# COMAL COUNTY

## Permit of Authorization to Construct an On-Site Sewage Facility Permit Valid For One Year From Date Issued

Permit Number: 117119  
Issued This Date: 03/13/2024  
This permit is hereby given to: Mark Ellison Williams

971 HILLCREST FOREST  
CANYON LAKE, TX 78133

Site map  
Proprietary Disposal system  
with leaching chambers and  
septic tank treatment  
Mark Ellison Williams  
Lot 409, Canyon Lake Forest,  
Unit 1, .53 acres  
971 hillcrest Forest  
Canyon Lake, Texas 78133  
Comal County

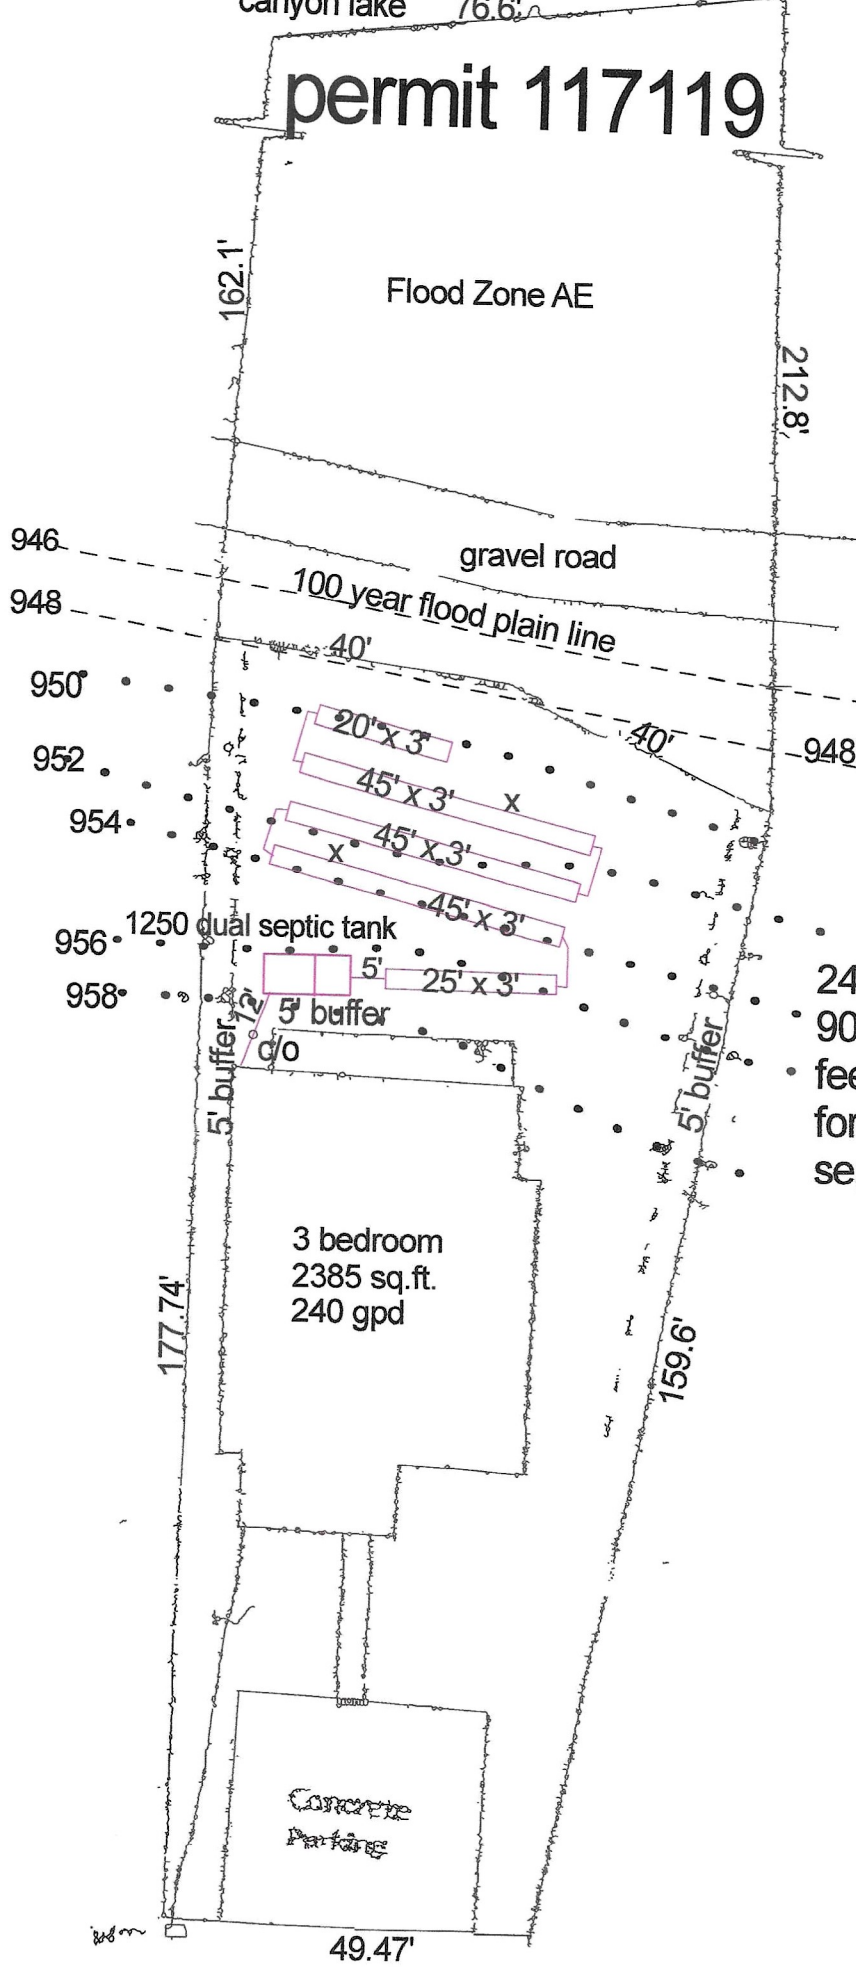
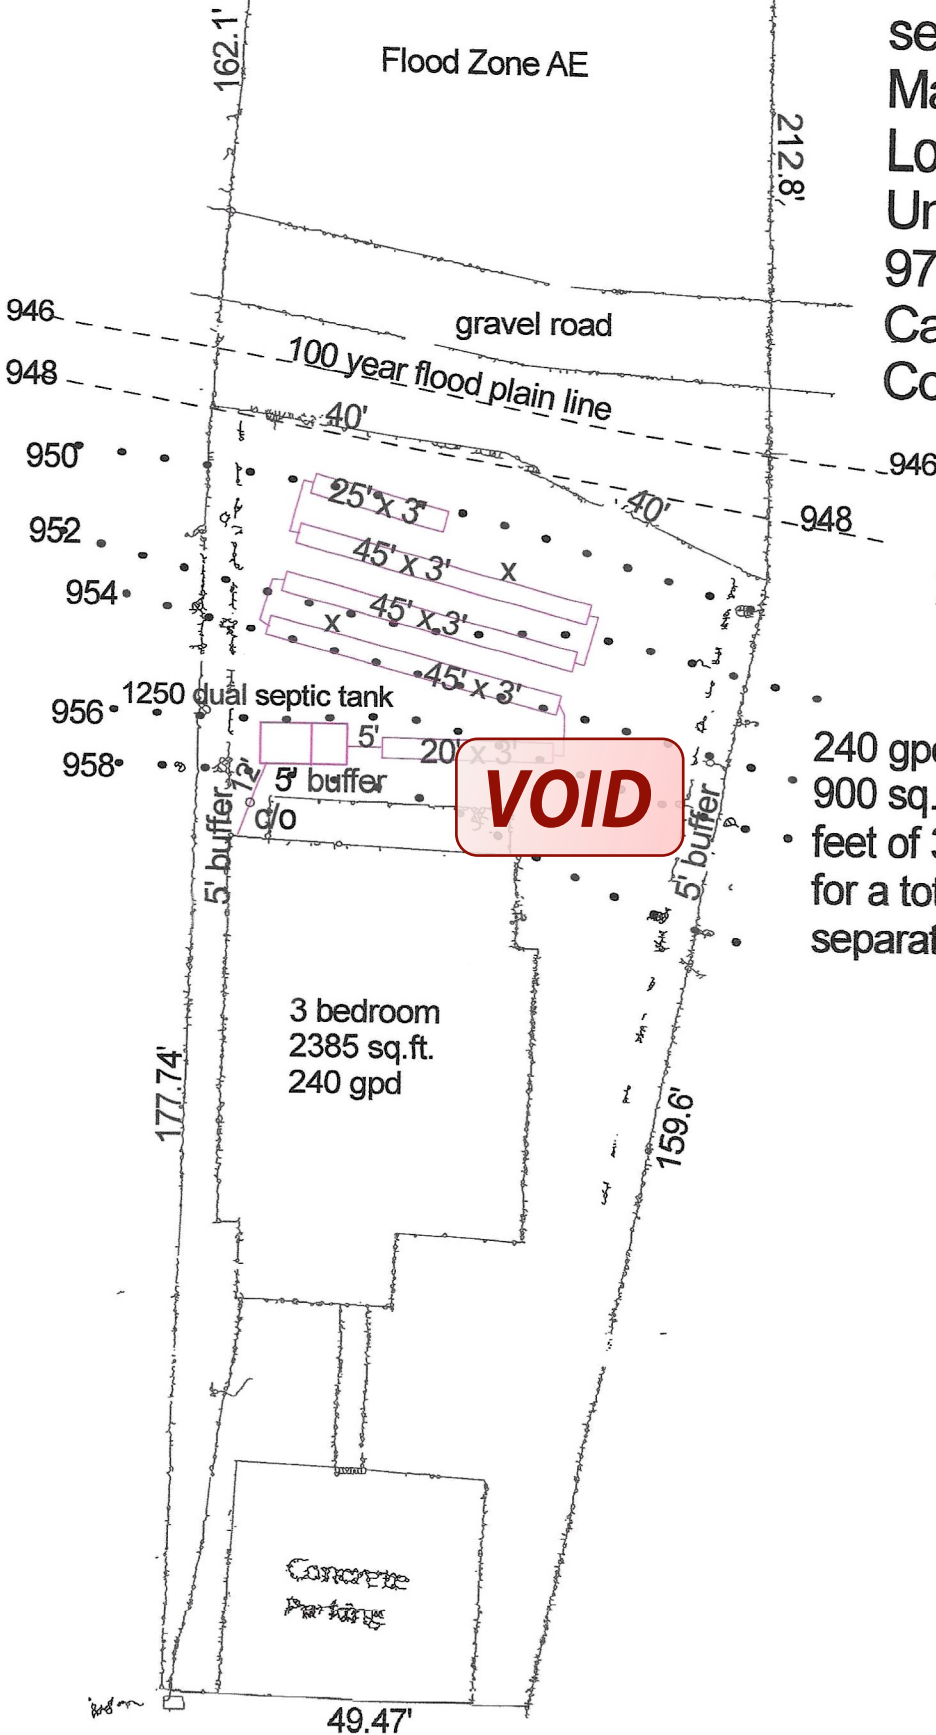
attached is a revised site map. I had the 25' and 20' labeled incorrectly

I have updated the permit file with your revised design.

**Site Map**  
 Conventional System with  
 Septic Tank and Leaching Chambers  
 Mark Ellison Williams  
 971 Hillcrest Forest  
 Canyon Lake, TX 78133  
 Lot 409, Canyon Lake Forest, Unit 1  
 .53 Acres

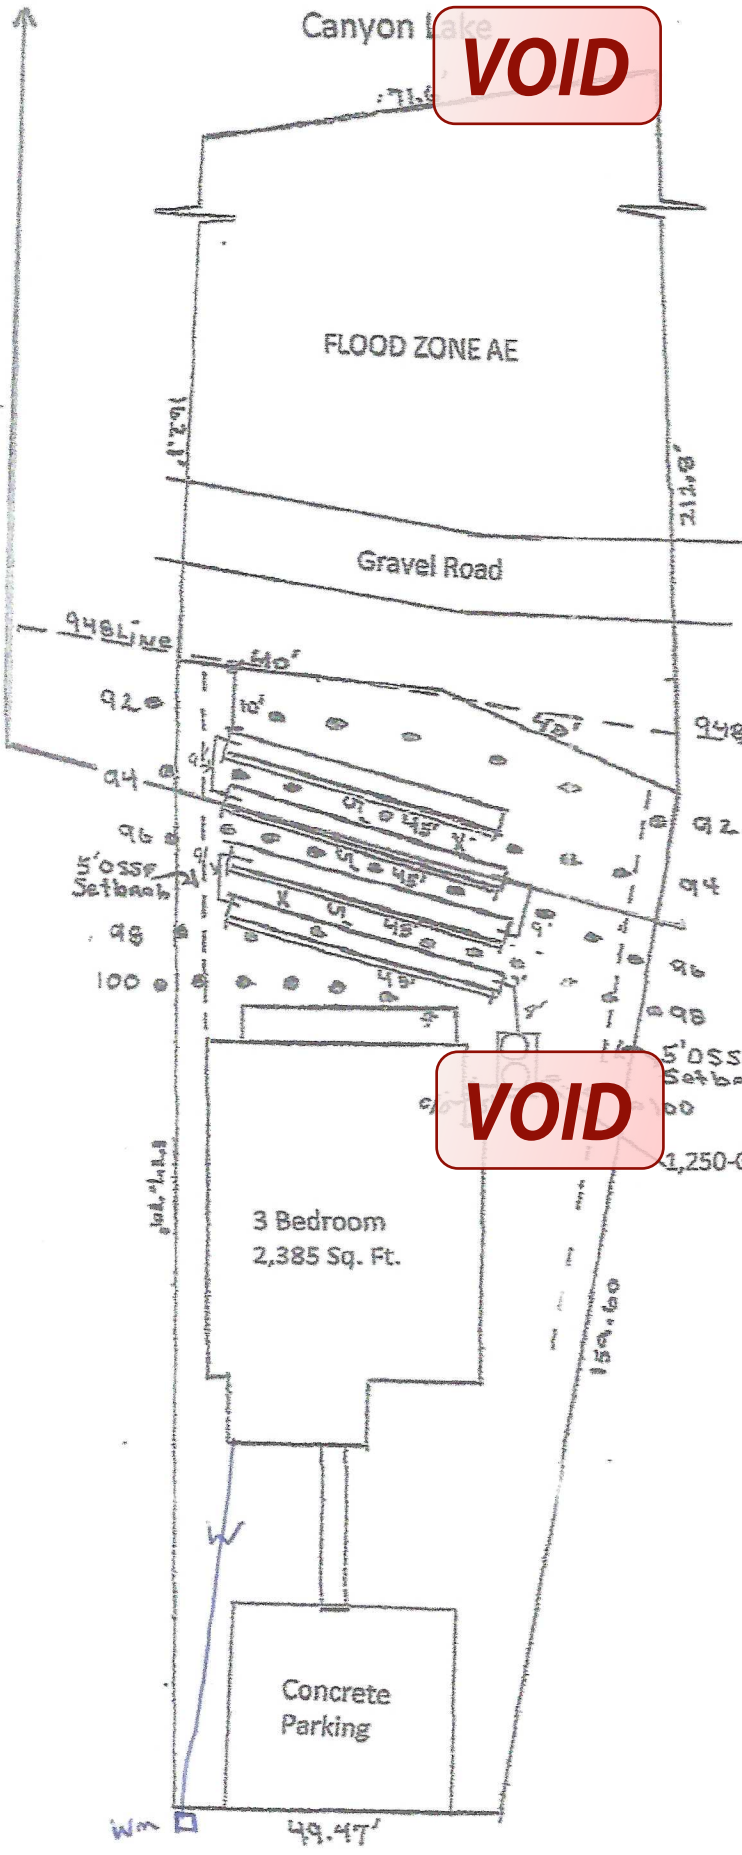
- ✓ There appear to be errors on the written description of the system being installed. Please recheck the chamber dimensions and number of panels per trench indicated on the design page.
- ✓ Show the boundaries of the flood plain on the design.
3. Revise as needed and resubmit.

**240 GPD - Drain Field Layout**  
 900 Sq.-Ft. Drain Field with 180 Linear Feet of  
 3" x 5" Leaching Chambers Installed in 4 Rows  
 at 45' Each with 8 Chambers Per Row for a  
 Total of 36 Chambers 5' Separation Between  
 Each Row  
 X = Test Hole Locations
